Removal of the En-Route Dependency from the Goodwood (GWC) DVOR
Airspace Change Decision

CAP 1772 Contents

Published by the Civil Aviation Authority, 2019

Appendix A - One unused procedure will be withdrawn

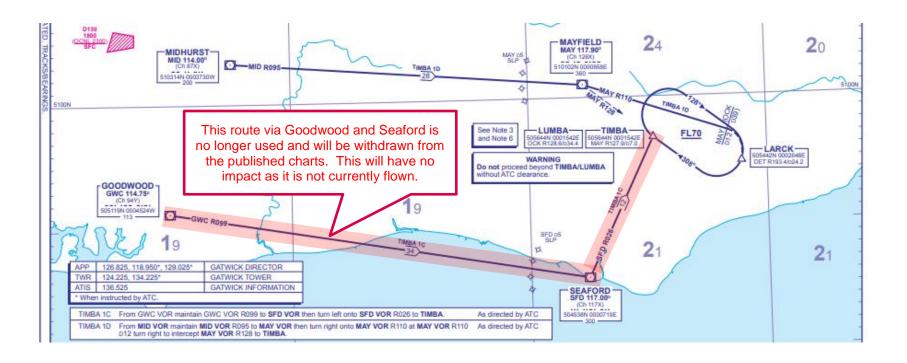
This is the only significant change to a published procedure. All other changes will have no material impact.
